Planning Commission Agenda

Planned Unit Development – Panera

Site: 27777 Southfield Road
Applicant: The Lawrence Group
Plan Date: April 28, 2022
Zoning: VC – Village Center District
Parcel ID: 24-14-432-006
Proposal: Planned Unit Development – Restaurant with drive-through

SITE DEVELOPMENT PLAN

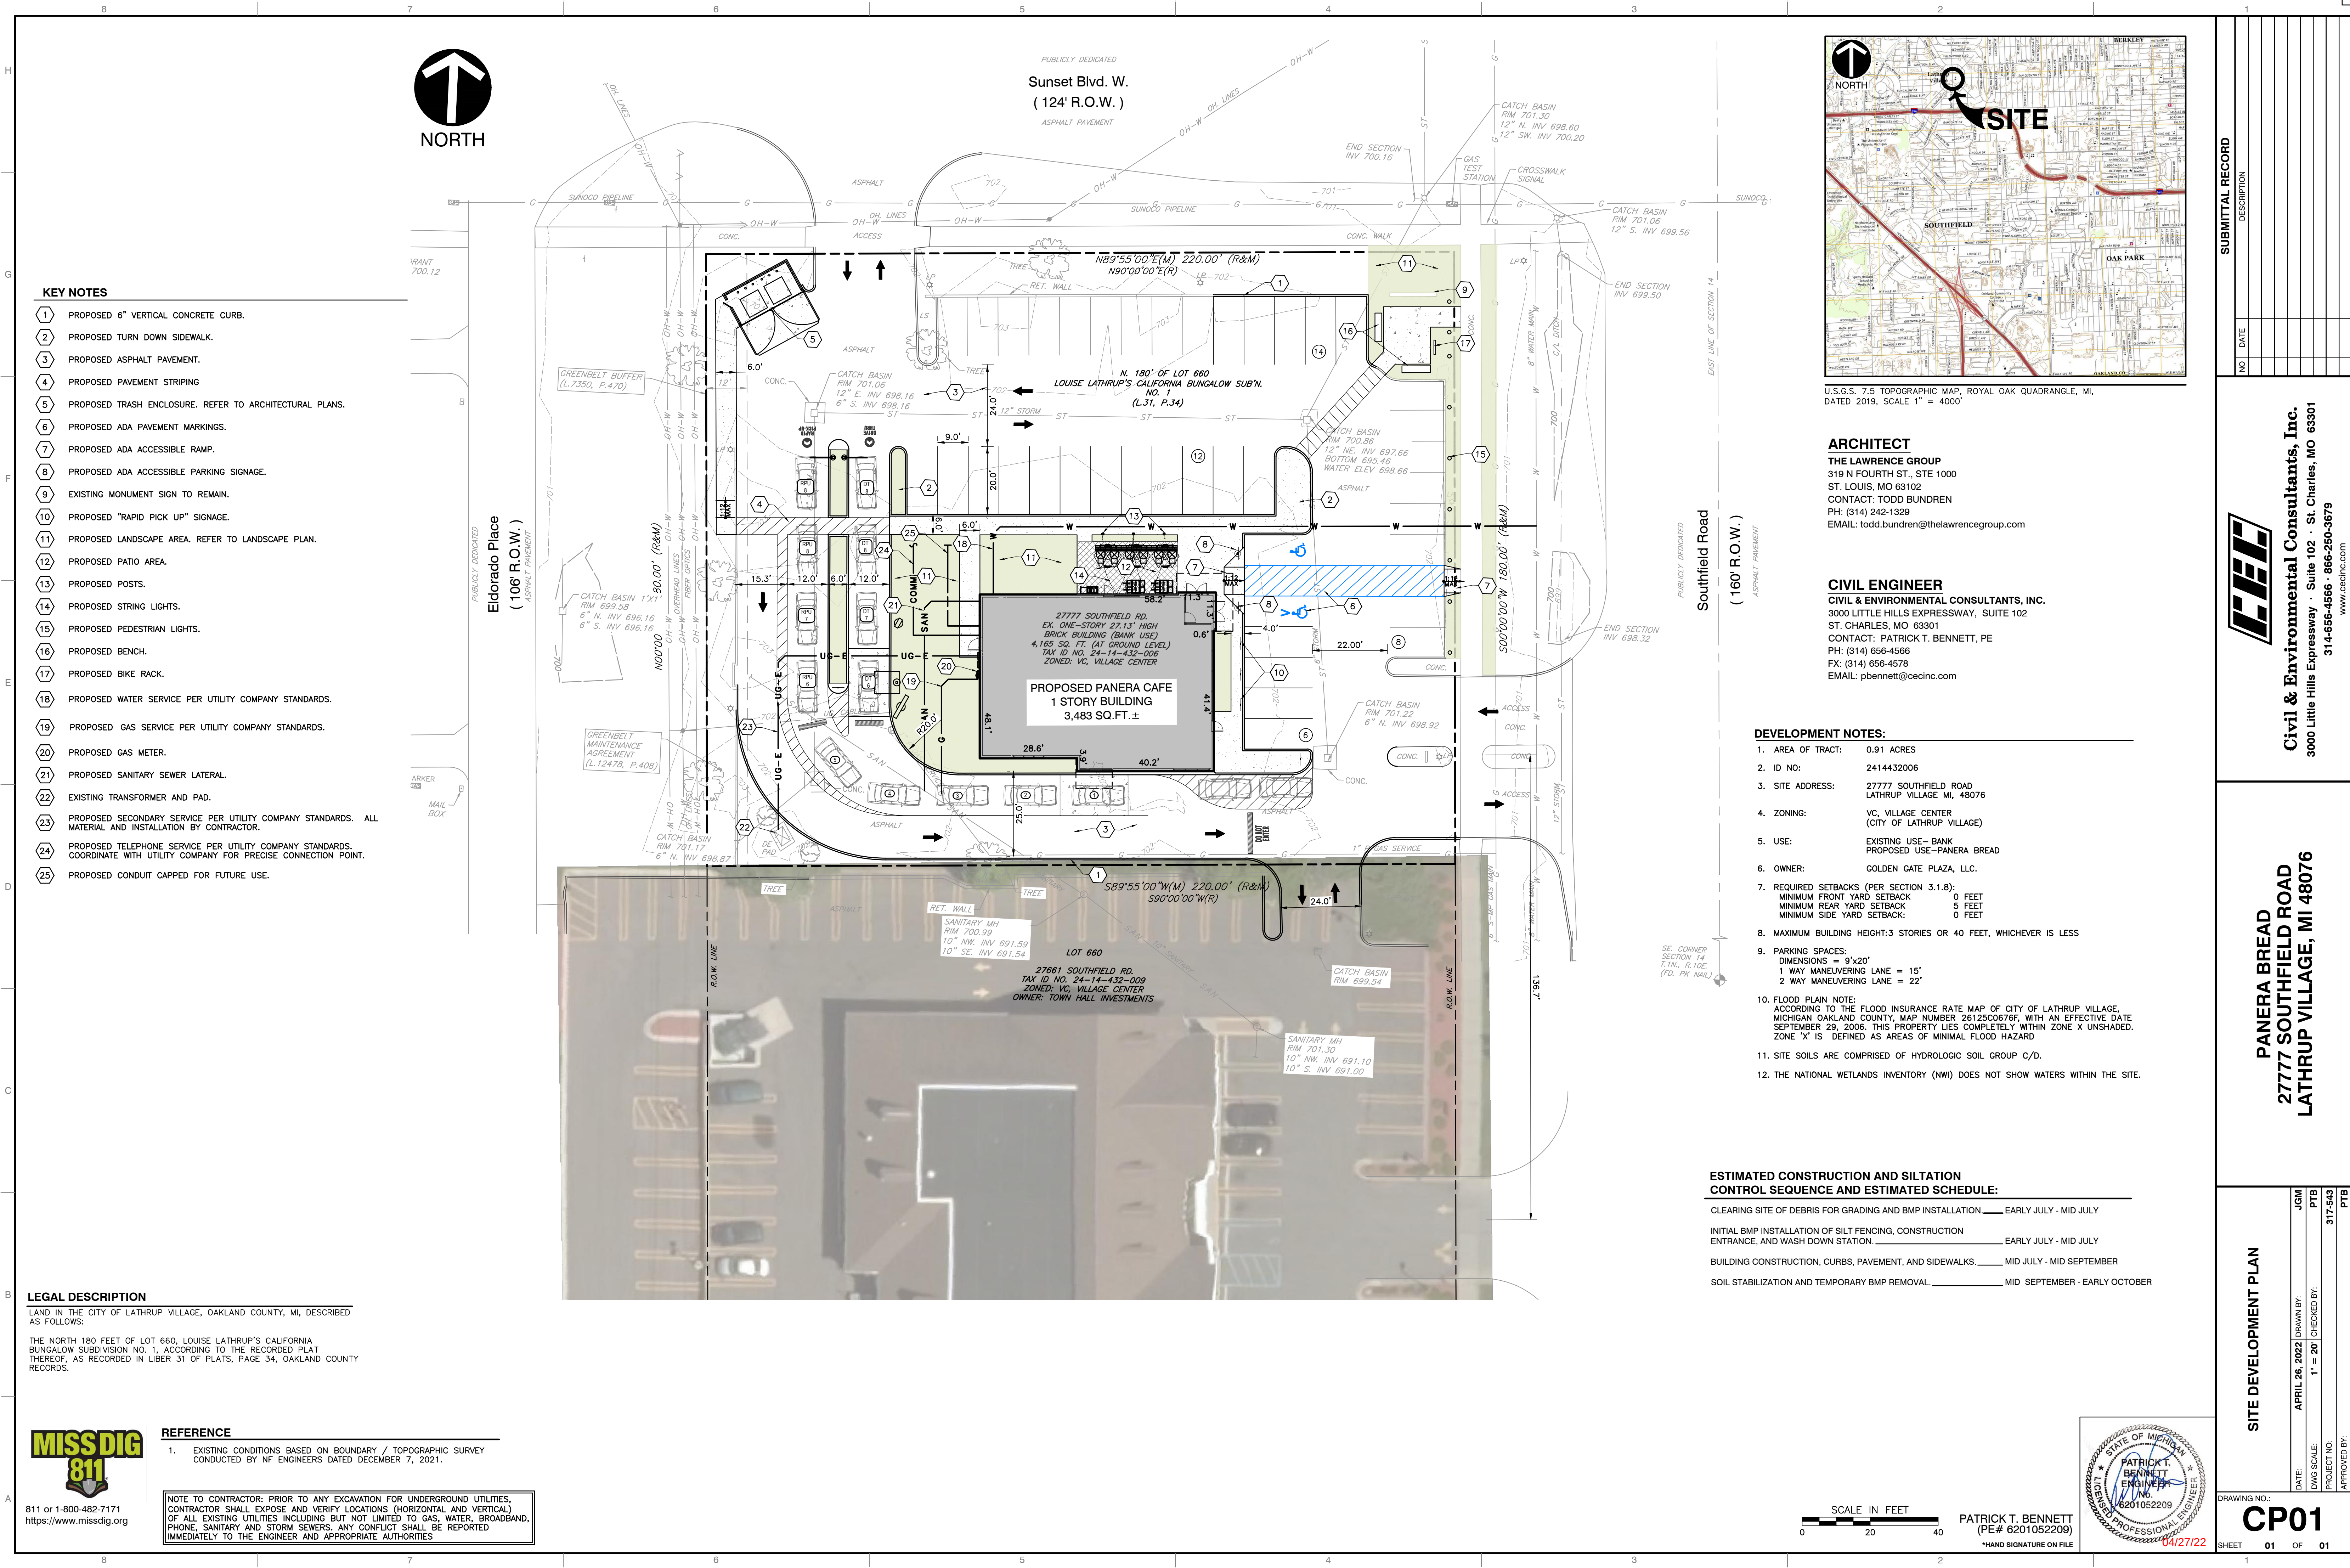
6. **Off-street Parking.** 1) The corner lot has three front yards along three street frontages, all of which prohibit surface parking in these locations within the Village Center District. The fourth side of the site contains the paving of the drive-through lanes, resulting in a complete encompassing of the proposed building by surface paving. 2) Parking for this use is one space per 70 sf of GFA or one space per two employees plus one per two maximum customers plus 10-vehicle stacking spaces per drive-thru lane. The applicant has not provided this information. A parking analysis is required for the proposed development indicating the number of parking spaces provided to meet the minimum required under Section 5.13.13.

7. **Functional Elements.** Based on the building square footage, the ordinance requires one designated loading area on-site, which is not identified on the site plan. Additionally, the proposed location of the dumpster enclosure is at the intersection of two public streets, one of which (Eldorado Place) consists of single-family residential homes. The applicant shall demonstrate that adequate screening is provided for all elements under this section.

5. Shared Parking: see section 5.13.5
 6. Bicycle Parking: Secure, visible, and accessible parking for bicycles shall be provided. **A bicycle rack is shown in the northeast corner of the site. A location closer to the restaurant may enhance the security of the parked bicycles. Verify the rack is capable of locking more than one bicycle.**

- a) **The plans should identify the one (1) required 10' x 40' loading space for the proposed 3,000+ square foot building.**
 - b) Dumpsters shall be permitted in the side or rear yard, provided that no dumpster shall extend closer to the front of the lot than any portion of the principal structure and provided further that the dumpster shall not encroach on a required parking area, is clearly accessible to servicing vehicles, and is located at least ten (10) feet from any building. Dumpsters shall comply with the setback requirements for the district in which they are located. Dumpsters shall be located as far as practicable from any adjoining residential district (5.3.3). **The dumpster enclosure is located at the northwest corner of the site, at the front yard intersection of Sunset Boulevard and Eldorado Place. This location is in close proximity to adjacent single-family residential lots to the west. The applicant shall demonstrate adequate screening per the requirements of Section 5.3.3.E.**
